From: Boryn, Agnes <agnes.boryn@westyorkshire.police.uk>
Sent: 13 January 2026 11:02
To: Victor Grayson; DC Admin
Subject: DOCO comments for application 2025/93449 at land east of Abbey Road North, Shepley, Huddersfield, HD8 8FG

Re: 2025/93449- Discharge of details reserved by conditions 27 (crime prevention), 29 (boundary treatments), 30 (external lighting) and 31 (landscaping) of previous permission 2024/90991 for variation of conditions 2 (plans) and 28 (materials) of previous permission 2020/93358 for erection of 52 dwellings

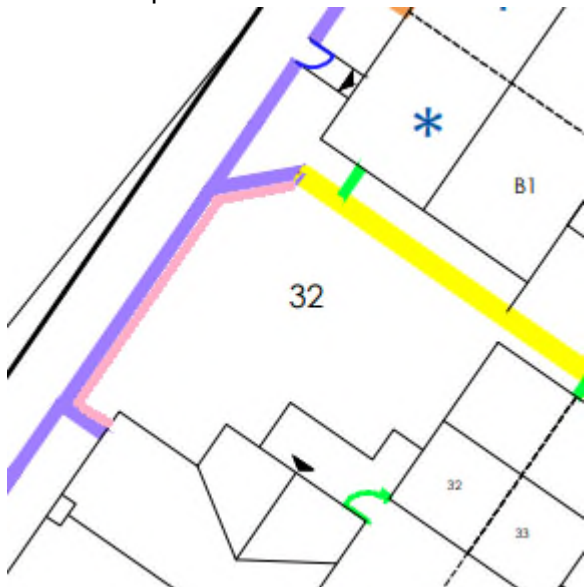
With regard to boundary treatments consisting of walls topped with trellis fencing- all trellis panels on the external face should be located flush to the edge of the wall to deter climbing and its use as informal seating.

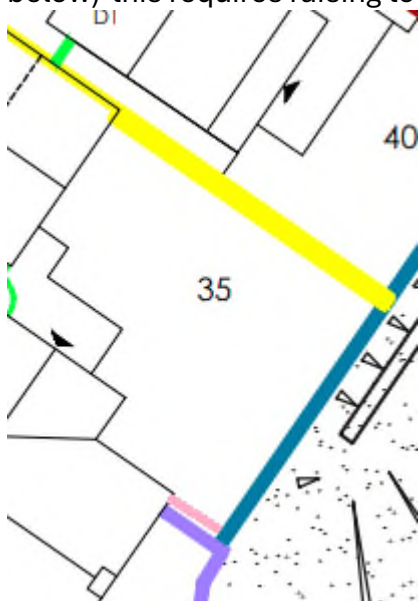
Plot 32- street-facing side of rear garden appears to be enclosed only with a 0.9m dry stone wall; this is insufficient in terms of security. The boundary should be raised to at least 1.8m along the lines marked in pink below:

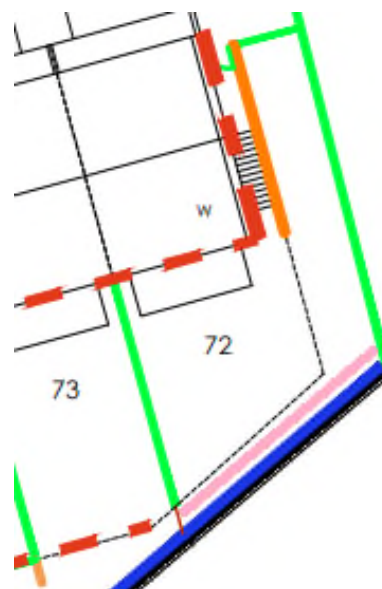
Plot 35's rear garden also has a weak point in its boundary for the same reason (marked in pink below)-this requires raising to 1.8m:
